Work Order ID 61971

Item ID:	D3687-1	Accept		Setup	Start	
Revision ID:					Stop	
Item Name:	MOUNT					
Start Date:	9/13/2010	Start Qty: 3.00		Cust Item ID:		
Required Date:	9/13/2010	Req'd Qty: 3.00		Customer:		
Reference:

D3687-1 MOUNT

From: David Shepherd [dshepherd@dartaero.com]
Sent: Thursday, September 02, 2010 3:52 PM
To: 'Marc Bellavance'
Cc: 'Jason Murdoch'
Subject: RE: D205-770-011 Replacement Engine Mount Kit
Attachments: image002.jpg

**D3687-3 MOUNT**

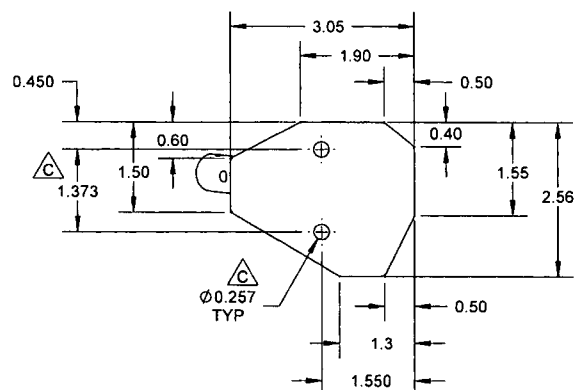
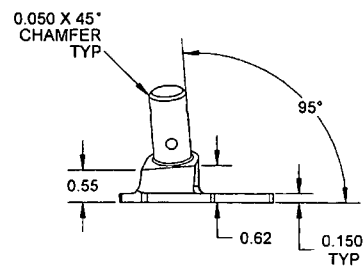
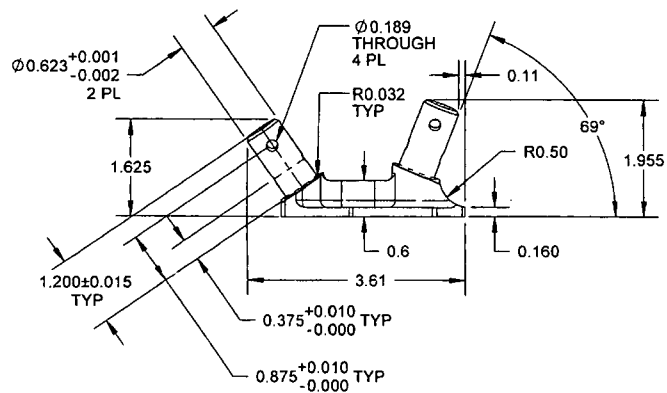
Per Jason's investigation, the 0.189" holes on P/N D3687-1 are indeed too small (0.185" to 0.187") on pretty much all the parts we have in stock and therefore, it is impossible to insert the required bolts through.

Question is: can manufacturing has your authorization to rework the part so we can ship the Kit to our customer? Also, is LPI required after the rework?

Yes ... It is acceptable to open up the holes slightly. I do not feel an LPI is required after the rework.
